Montana Resources 6560 Amendment Report

Report of the Independent Review Panel

Design Document for Expansion of Yankee Doodle Tailings Impoundment to El. 6560 Ft.

Final Report May 18 2025

Figure 4. Cross section showing interpretation of the phreatic surface at station 0+00, overlain on the monitored pore pressure conditions from the end of 2021, as presented in the Data Analysis Report.

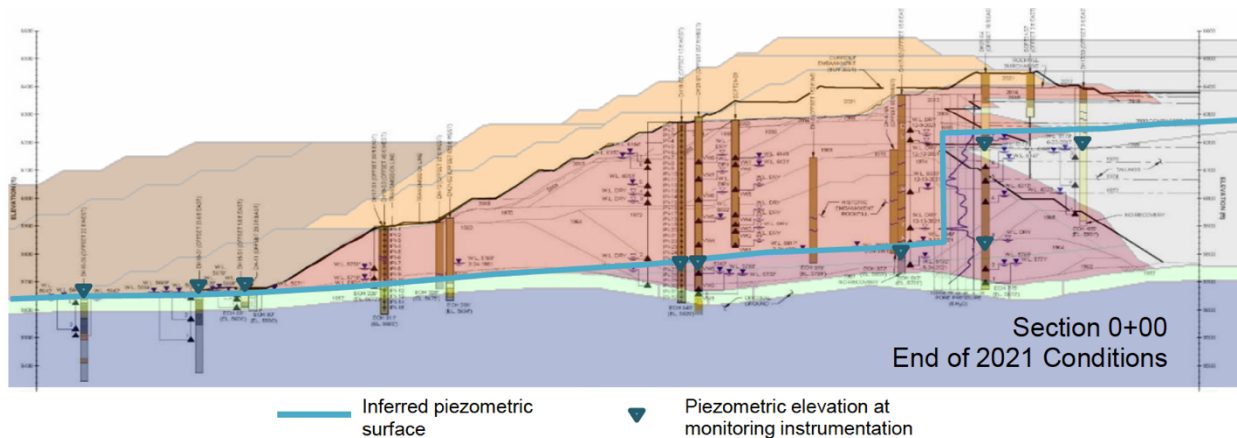
KP identify two main hydrogeologic regimes, an upper regime in the tailings and a lower regime that subdivides the rockfill within the embankment near its base. The basal saturated zone is thickest at the upstream face and thins towards the original ground surface at the downstream toe. The two regimes are linked with a vertical transition near the upstream face of the embankment to form a single continuous surface. A cross section illustrating the interpreted hydrogeologic regimes is shown in Figure 4. The IRP concurs with this schematic interpretation.

Figure 5. Water balance model calibration and forecast for Scenario 1

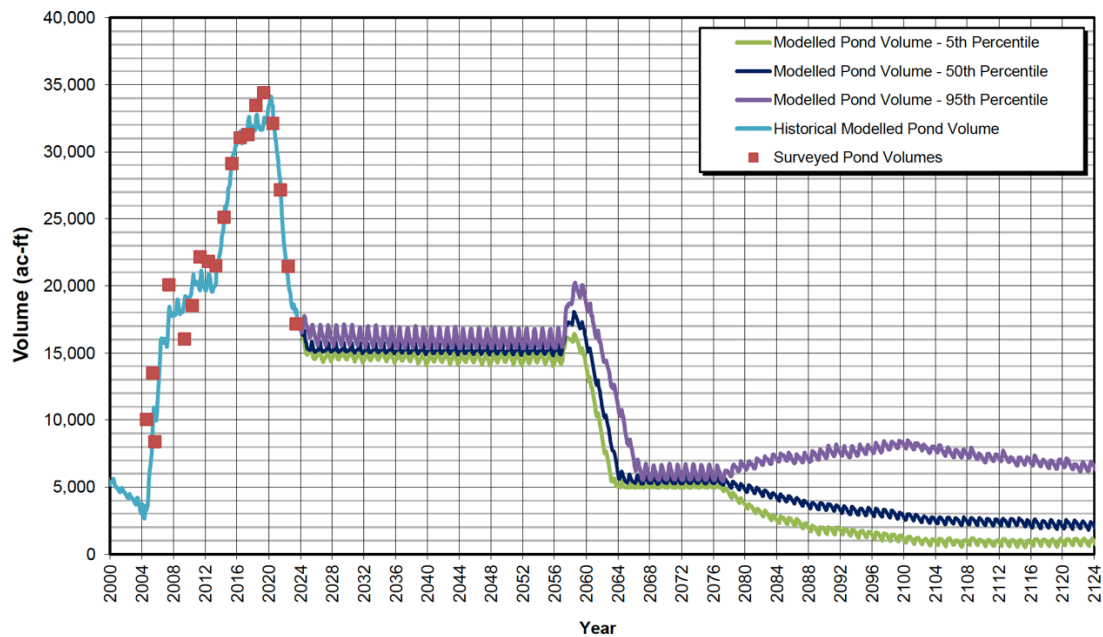
The forecast water volume for Scenarios 1 and 2 are shown in Figure 5 and 6, respectively. The principal difference between Scenario 1 and 2 is the time required to draw down the YDTI to its target closure volume of about 5000 acre-ft. These curves also indicate the range in YDTI pond volume that could occur in the closure period for the normal variation in climatic cycles.

Figure 7. Two-dimensional model of groundwater flow on western side of YDTI (by Hydrometrics), at completion of 6560 raise

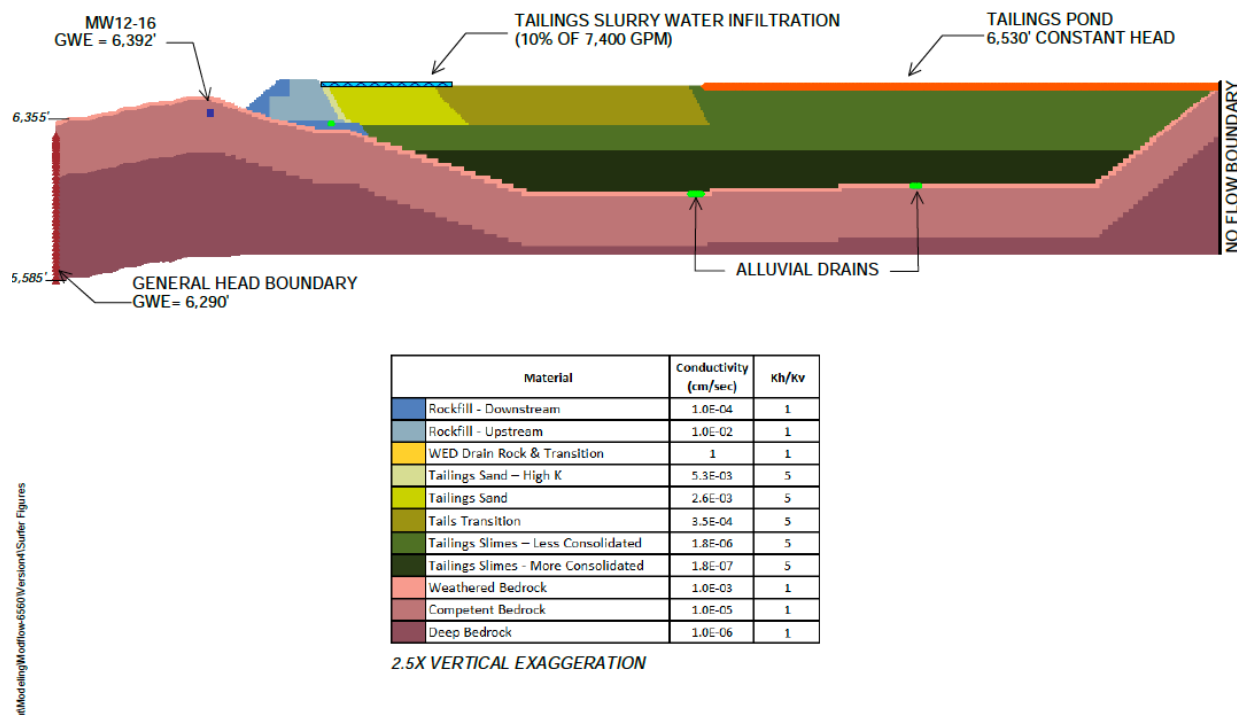
Figure 7 shows the revised two-dimensional model domain, hydrostratigraphic units, and assigned boundary conditions for active deposition with the YDTI tailings facility embankments at El. 6450 ft. and a pond elevation of 6530 ft. The WED drain within the west embankment is assumed to be fully functional.

The IRP considers the updated 2D model is fit for purpose to examine the potential impact on hydrodynamic containment along West Ridge following raising the TSF by 110 ft, with an ultimate pond elevation of 6530 ft. Key elements incorporated in the model are:

Figure 8. Projected hydraulic head distribution and groundwater path lines for 6560 scenario (from Hydrometrics, 2024)

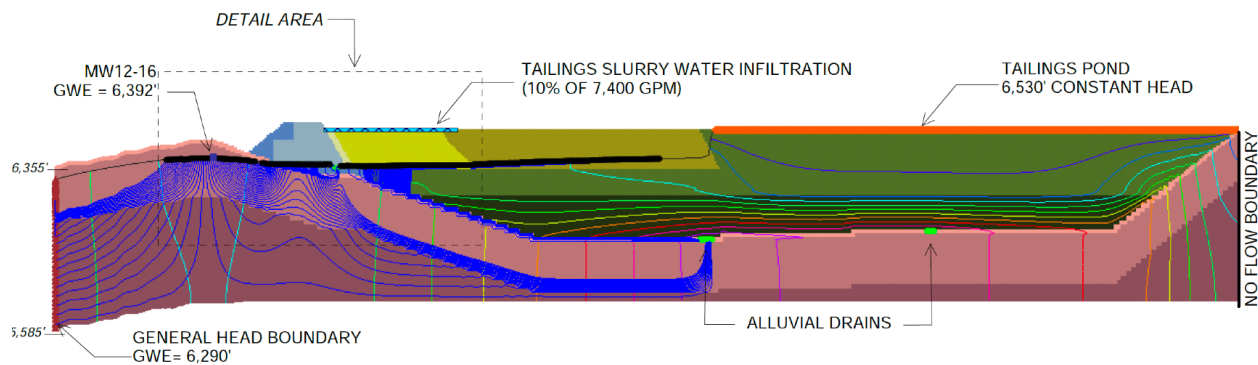
The simulations and sensitivity cases indicate that with the WED functional, hydrodynamic containment along the West Ridge can be maintained throughout the operating life of the YDTI to an embankment height of 6560 ft and pond elevation of 6530 ft (Figure 8). The IRP considers the model analysis provides a sound basis to support this conclusion.

Figure 9. Projected inundation zone for a hypothetical breach of the North South Embankment, occurring as the El 6560 ft raise reaches its design capacity

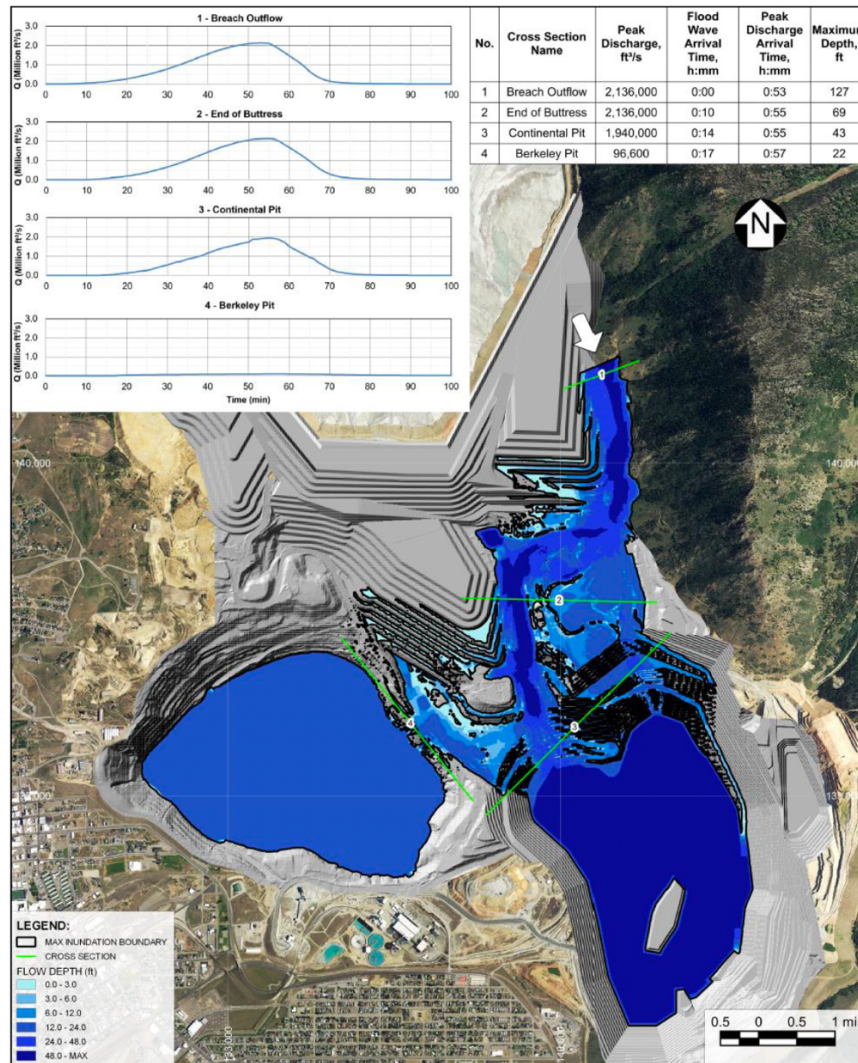
The assumed location of the breach and the projected inundation zone are shown in Figure 9 for the base case parameter set. KP has long considered a potential breach of the North South embankment to be a more credible failure mode than a failure of the East-West or West embankments and rock buttresses, although this view is distinct from the likelihood of a breach event occurring. The IRP considers the chosen breach location and specified breach mechanism are sufficient to inform Montana Resources and KP on the potential consequences of a YDTI dam breach when the TSF reaches full capacity and to aid in response planning. A sunny day failure of the YDTI would be expected to lead to a much smaller tailings inundation zone, given the projected location of the pond well away from any embankment when the TSF reaches capacity, and the consequent substantially lower mobility of the tailings mass. For the purpose of impact assessment from a hypothetical breach, it is considered sufficient by the IRP to focus on the flood-induced scenario for the 6560 permit amendment.

As Figure 9 shows, a sufficient storage volume is present in the two open pits to contain all the mobilized tailings and pond water released in this simulation, even when the pits hold the projected surface water runoff from the surrounding area due to the PMF event. The tailings and pond water remain within the property boundaries. No flow paths are

projected to develop where tailings bypass the two open pits. Most of the tailings and pond water that is mobilized ends up in the Continental Pit. The corridor between the YDTI and Ramparts Mountain, as well as the area to the immediate south have peak flows that would lead to loss of life if any individuals in the area were not evacuated prior to or in the early minutes after the start of the breach. This information will need to be incorporated in the Emergency Response Plan that would be relevant to the time period represented by this breach scenario.
